SUBJECT: VIRGIL C. SUMMER NUCLEAR STATION, UNIT 1 - STAFF ASSESSMENT OF INFORMATION PROVIDED PURSUANT TO TITLE 10 OF THE *CODE OF FEDERAL REGULATIONS* PART 50, SECTION 50.54(f), SEISMIC HAZARD REEVALUATIONS RELATING TO RECOMMENDATION 2.1 OF THE NEAR-TERM TASK FORCE REVIEW OF INSIGHTS FROM THE FUKUSHIMA DAI-ICHI ACCIDENT (TAC NO. MF3831)

STAFF ASSESSMENT BY THE OFFICE OF NUCLEAR REACTOR REGULATION

RELATED TO SEISMIC HAZARD AND SCREENING REPORT

VIRGIL C. SUMMER NUCLEAR STATION, UNIT 1

Figure 3.2-1 Plot Comparing the Staff's and the Licensee's Mean Control Point Hazard Curves at a Variety of Frequencies. RAI Response Curves are Licensee Curves Developed Using the Currently Endorsed CEUS-SSC for the VCSNS site

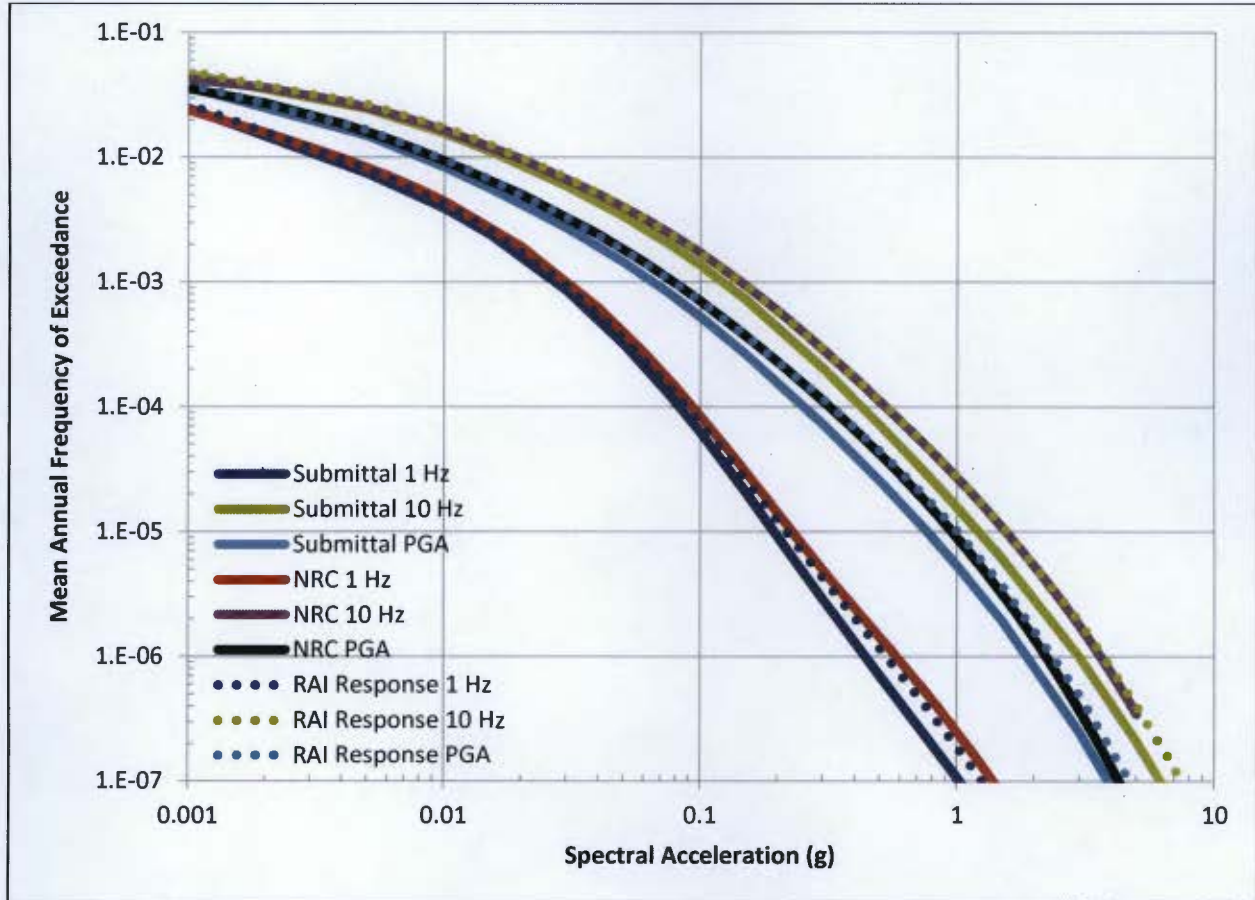
Figure 3.2-1 of this assessment shows the hazard curves developed by the licensee using the modified CEUS-SSC, the hazard curves developed by the licensee using the original CEUS-SSC, and the hazard curves developed by the NRC staff for three of the seven spectral frequencies. The hazard curves developed by the licensee using the original CEUS-SSC model without the catalog revisions are, as expected, the same as the curves developed by the NRC staff. The hazard curves developed by the licensee using the modified CEUS-SSC are consistently lower than those developed using the original CEUS-SSC by about 6 to 16 percent, which indicates that the licensee's revisions to the catalog for the southeastern U.S. had a modest but not insignificant impact.

Figure 3.4-1 Comparison of the Staff's GMRS with Licensee's GMRS and the SSE for the VCSNS site

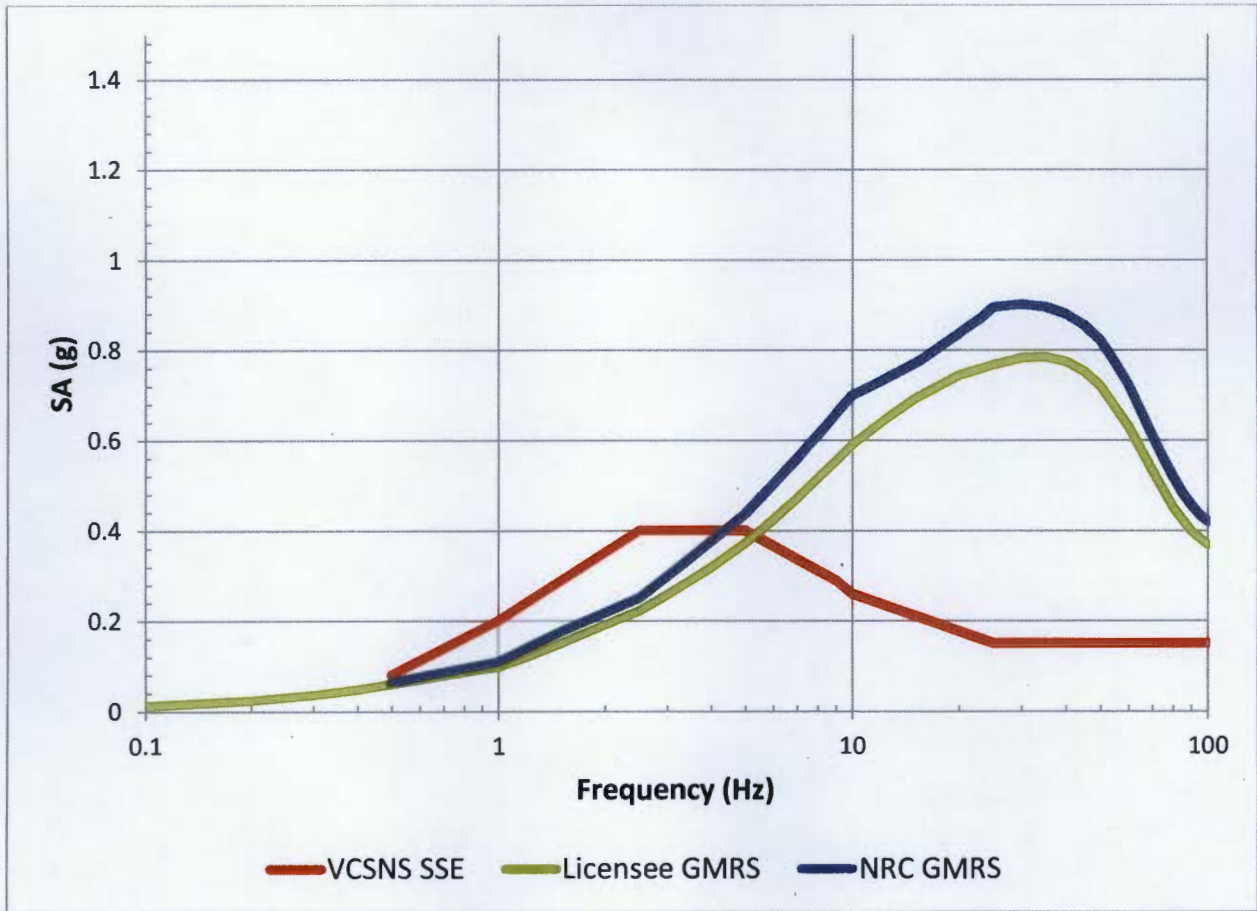
The NRC staff independently calculated the  $10^{-4}$  and  $10^{-5}$  UHRS using the results of its confirmatory PSHA, as described in Section 3.2 of this staff assessment. Figure 3.4-1 of this assessment shows a comparison of the GMRS determined by the licensee to that determined by the NRC staff.

As shown in Figure 3.4-1, the licensee's GMRS shape is generally similar to that calculated by the NRC staff at all frequencies. However, the NRC staff's confirmatory GMRS is slightly higher than the licensee's. As described in Section 3.2, the NRC staff concludes that these differences are due to changes the licensee made to the published CEUS-SSC catalog when conducting the PSHA.

Based on the NRC staff's review of the licensee's SHSR, RAI response and SSHAC report, the staff confirms that the licensee used the present-day guidance and methodology outline in RG 1.208 and the SPID to calculate the horizontal GMRS, as requested in the 50.54(f) letter. The NRC staff performed a PSHA confirmatory analysis and achieved results consistent with the licensee's base rock hazard curves developed with the CEUS-SSC as published. As such, the NRC staff concludes that the GMRS determined by the licensee adequately characterizes the reevaluated hazard for the VCSNS site for the purposes of screening. Because the NRC staff accepted the licensee's SSHAC Level 2 study justifying modifications for the limited purpose of response to the 50.54(f) letter, the staff concludes that the GMRS determined by the licensee adequately characterizes the reevaluated hazard for the VCSNS site. Therefore, this
